ASBURY CENTRETECH INVENTORY PARKING LOT

SITE PLAN

1st SUBMITTAL JASON IGO jigo@auroragov.org

ASBURY CENTRETECH
AURORA, COLORADO
SITE PLAN
COVER SHEET

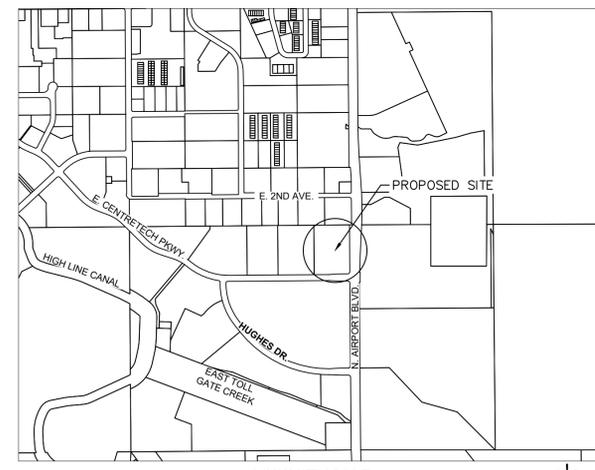
Title needs to match the title of the project in the system. Please revise to "Centretech Inventory Parking Lot"

This site plan will not be approved until the Preliminary Drainage Report is approved

Revise to '1-1' instead of 'I-1 Parking'

Please increase the size of the amendment block to the recommended size of 2"x3"

Please add the "Centretech Inventory Parking Lot Site Plan" above the Legal Description

Please correct note #10 to read as follows: THE DEVELOPER, HIS SUCCESSORS AND ASSIGNS SHALL BE RESPONSIBLE FOR INSTALLATION, MAINTENANCE AND REPLACEMENT OF FIRE LANE EASEMENTS CONSTRUCTED WITHIN THIS SITE USING ALTERNATIVE SURFACING MATERIALS SUCH AS, BUT NOT LIMITED TO; GRASSPAVE, GRASS CRETE, RITTER RINGS, INVISIBLE STRUCTURES UTILIZED ONLY FOR EMERGENCY VEHICLE ACCESS USE. THIS AGREEMENT WILL INCLUDE SNOW REMOVAL TO ENSURE EMERGENCY ACCESS IS AVAILABLE AT ALL TIMES. IF THE ABOVE CONDITIONS ARE NOT MET, THE OWNERS, HIS SUCCESSORS AND ASSIGNS SHALL BE REQUIRED BY ORDER NOTICE FROM THE AURORA FIRE DEPARTMENT TO REMOVE THE INVISIBLE STRUCTURE AND REPLACE IT WITH AN ASPHALT OR CONCRETE ROAD SURFACE THAT MEETS THE CONSTRUCTION REQUIREMENTS OF THE PUBLIC WORKS DEPARTMENT FIRE LANE STANDARDS AND BE SHOWN IN DETAIL WITHIN THE CIVIL PLANS.

Please provide additional Site Data such as Accessible Parking, Occupancy Classification, and Occupant Load of the Building to be on site.

Please add the Right of Way note as shown.

This has been revised.

Title has been revised to "Centretech Inventory Parking Lot"

Amendment block has been increased to be 2" in height.

This has been added above the legal description.

Updated.

Occupancy classification and occupant load have been added to the site data table. Please note, the auxiliary building is not considered habitable and will not be manned. Accessible parking is currently being shown on the table.

Right of way note has been added.

ASBURY CENTRETECH
AURORA, COLORADO
SITE PLAN
UTILITY PLAN

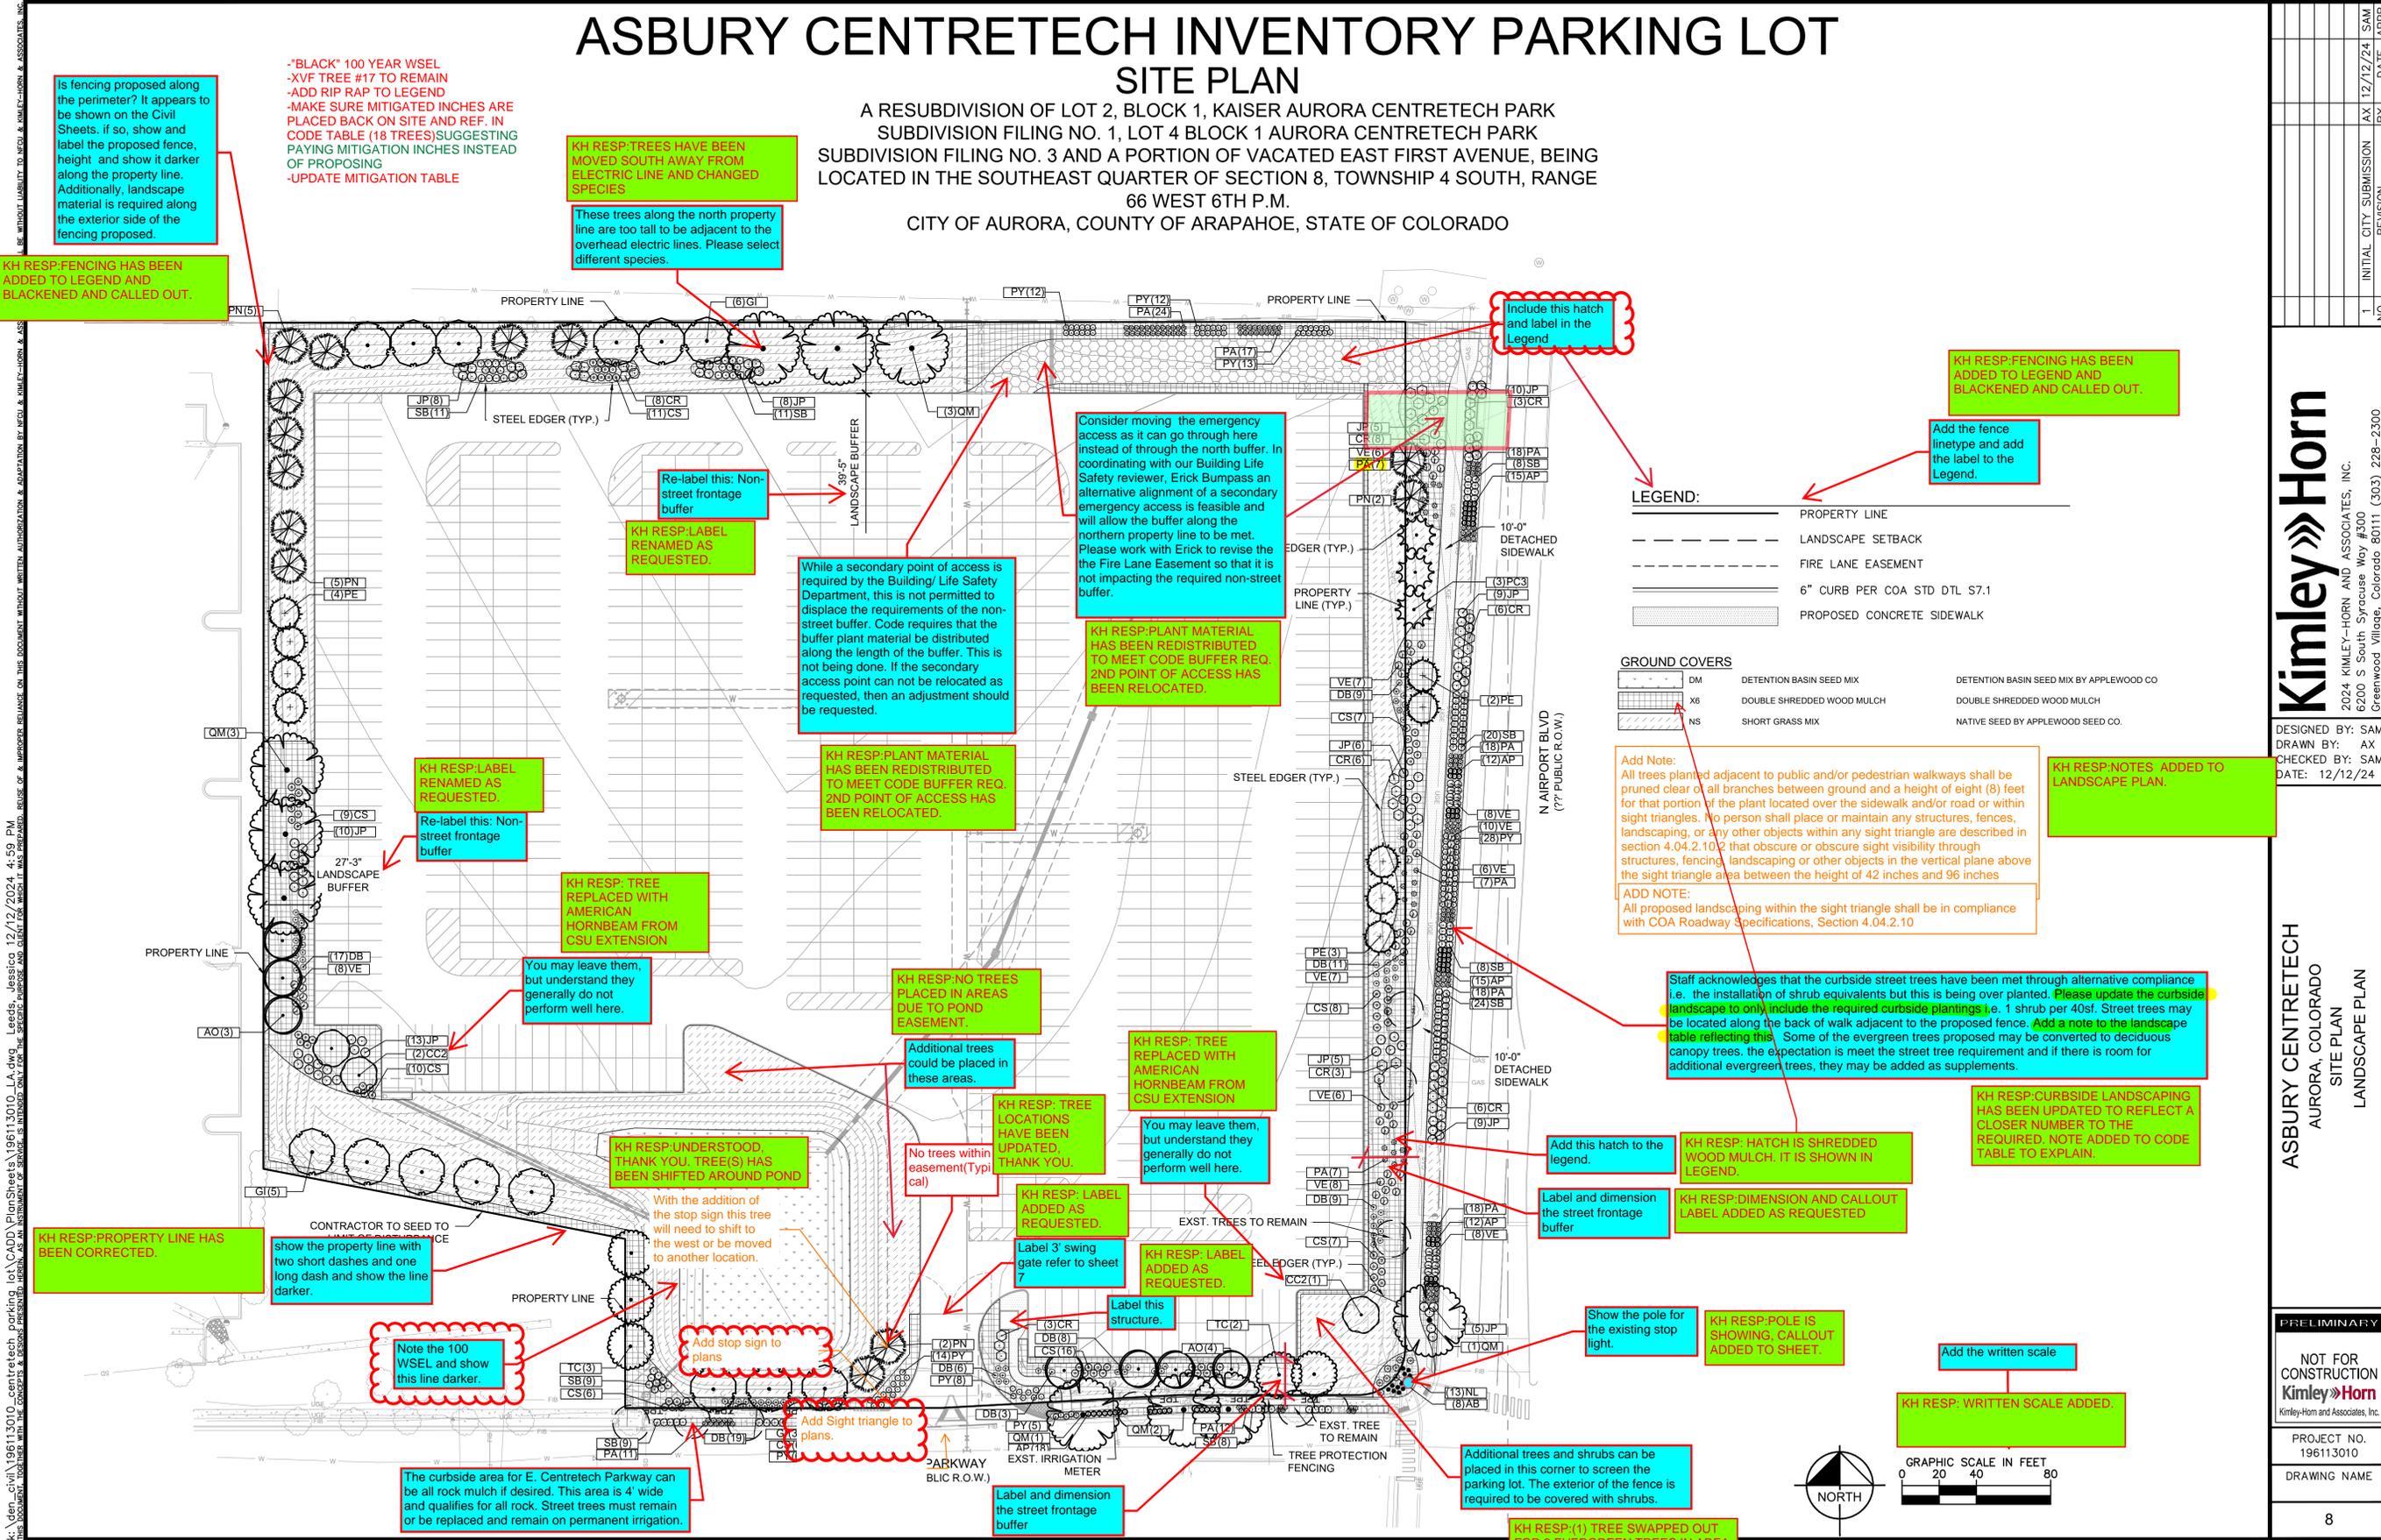
Eliminate this Weld on Tap and line to loop hydrants or use 2 laterals - 1 lateral per hydrant. Provide calculations showing minimum 20 psi to both hydrants.

Remove pipe type and diameter. These details will be on the Civil Plan (Typical)

Add "proposed" to water easement, provide by separate document (Typical)

Linear footages will be on Civil Plan but are not necessary on Site Plan. (Typical)

Eliminate "hydrant" from easement. (Typical)

Provide maintenance access to forebays and top/bottom of outlet structure per AW standards.

Existing utility easement will need to be released by separate document

Water main loop on site is now being provided from Centretech Pkwy.

Pipe type has been removed and will be added to the Civil Plans.

Linear footages have been removed and will be added to the Civil Plans.

Hydrant easements have been relabeled to "Utility Easement"

Maintenance path to forebays and outlet structure have been added.

Understood, existing utility easement will be released by separate document.

ASBURY CENTRETECH
 AURORA, COLORADO
 SITE PLAN
 LANDSCAPE PLAN

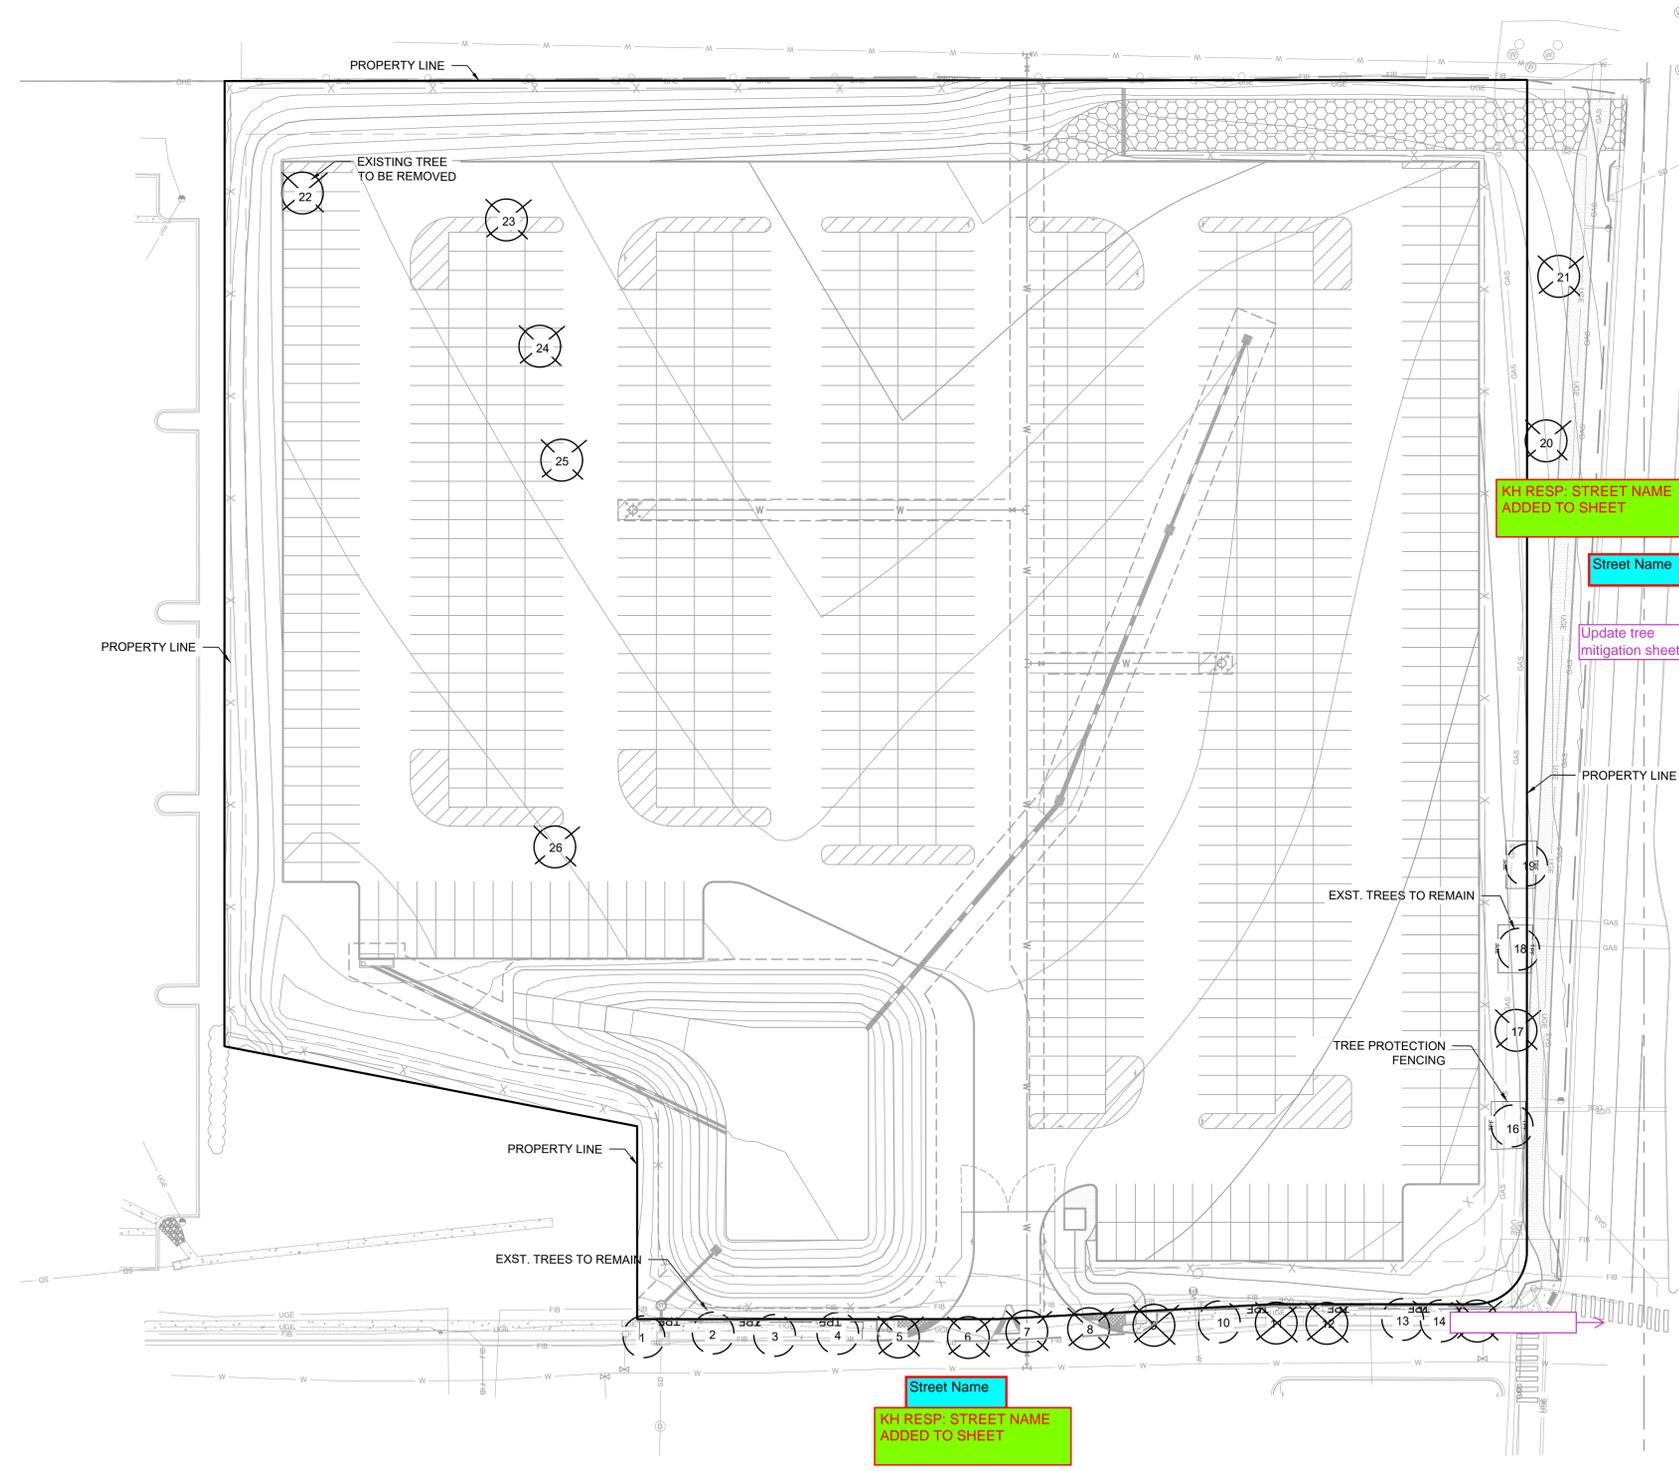
Is fencing proposed along the perimeter? It appears to be shown on the Civil Sheets. If so, show and label the proposed fence, height and show it darker along the property line. Additionally, landscape material is required along the exterior side of the fencing proposed.

These trees along the north property line are too tall to be adjacent to the overhead electric lines. Please select different species.

Add the fence linetype and add the label to the Legend.

Consider moving the emergency access as it can go through here instead of through the north buffer. In coordinating with our Building Life Safety reviewer, Erick Bumpass an alternative alignment of a secondary emergency access is feasible and will allow the buffer along the northern property line to be met. Please work with Erick to revise the Fire Lane Easement so that it is not impacting the required non-street buffer.

While a secondary point of access is required by the Building/ Life Safety Department, this is not permitted to displace the requirements of the non-street buffer. Code requires that the buffer plant material be distributed along the length of the buffer. This is not being done. If the secondary access point can not be relocated as requested, then an adjustment should be requested.

Additional trees could be placed in these areas.

Label 3' swing gate refer to sheet 7

Label this structure.

Staff acknowledges that the curbside street trees have been met through alternative compliance i.e. the installation of shrub equivalents but this is being over planted. Please update the curbside landscape to only include the required curbside plantings, i.e. 1 shrub per 40sf. Street trees may be located along the back of walk adjacent to the proposed fence. Add a note to the landscape table reflecting this. Some of the evergreen trees proposed may be converted to deciduous canopy trees. The expectation is meet the street tree requirement and if there is room for additional evergreen trees, they may be added as supplements.

Label and dimension the street frontage buffer

Show the pole for the existing stop light.

Add the written scale

Additional trees and shrubs can be placed in this corner to screen the parking lot. The exterior of the fence is required to be covered with shrubs.

The curbside area for E. Centretech Parkway can be all rock mulch if desired. This area is 4' wide and qualifies for all rock. Street trees must remain or be replaced and remain on permanent irrigation.

Add Note:
All trees planted adjacent to public and/or pedestrian walkways shall be pruned clear of all branches between ground and a height of eight (8) feet for that portion of the plant located over the sidewalk and/or road or within sight triangles. No person shall place or maintain any structures, fences, landscaping, or any other objects within any sight triangle as described in section 4.04.2.10 that obscure or obscure sight visibility through structures, fencing, landscaping or other objects in the vertical plane above the sight triangle area between the height of 42 inches and 96 inches

ADD NOTE:
All proposed landscaping within the sight triangle shall be in compliance with COA Roadway Specifications, Section 4.04.2.10

KH RESP: FENCING HAS BEEN ADDED TO LEGEND AND BLACKENED AND CALLED OUT.

KH RESP: TREES HAVE BEEN MOVED SOUTH AWAY FROM ELECTRIC LINE AND CHANGED SPECIES

KH RESP: FENCING HAS BEEN ADDED TO LEGEND AND BLACKENED AND CALLED OUT.

KH RESP: PLANT MATERIAL HAS BEEN REDISTRIBUTED TO MEET CODE BUFFER REQ. 2ND POINT OF ACCESS HAS BEEN RELOCATED.

KH RESP: PLANT MATERIAL HAS BEEN REDISTRIBUTED TO MEET CODE BUFFER REQ. 2ND POINT OF ACCESS HAS BEEN RELOCATED.

KH RESP: NO TREES PLACED IN AREAS DUE TO POND EASEMENT

KH RESP: LABEL ADDED AS REQUESTED.

KH RESP: DIMENSION AND CALLOUT LABEL ADDED AS REQUESTED

KH RESP: CURBSIDE LANDSCAPING HAS BEEN UPDATED TO REFLECT A CLOSER NUMBER TO THE REQUIRED. NOTE ADDED TO CODE TABLE TO EXPLAIN.

KH RESP: POLE IS SHOWING CALLOUT ADDED TO SHEET.

KH RESP: WRITTEN SCALE ADDED.

KH RESP: (1) TREE SWAPPED OUT FOR 3 EVERGREEN TREES IN AREA

KH RESP: EXISTING TREES AND PROPOSED SHRUBS TO REMAIN. THANK YOU FOR THE INFORMATION.

KH RESP: NOTES ADDED TO LANDSCAPE PLAN.

ASBURY CENTRETECH
 AURORA, COLORADO
 SITE PLAN
 PHOTOMETRIC PLAN

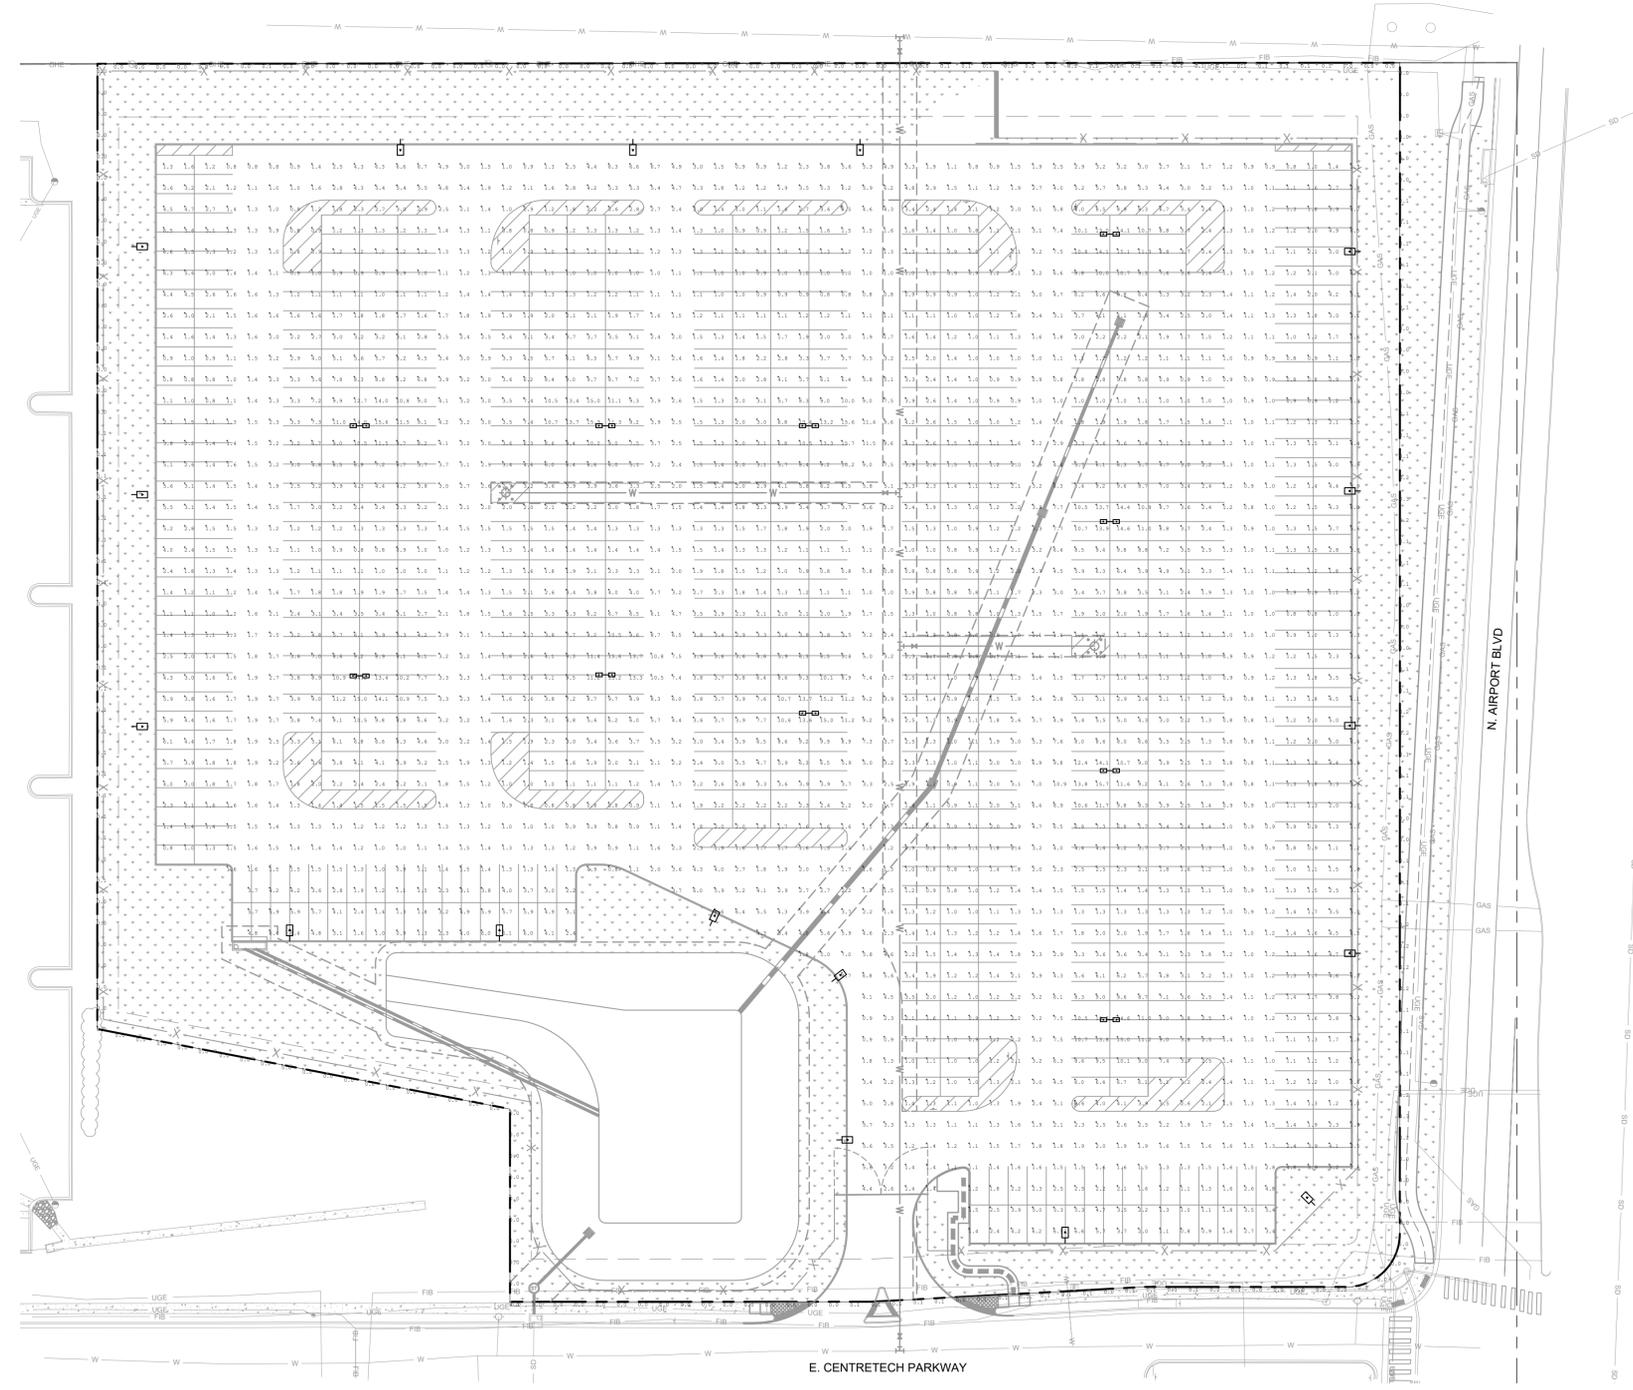
Streetlights on N. Airport Blvd and Centretech Pkwy will be evaluated at the Civil plan.

Understood.
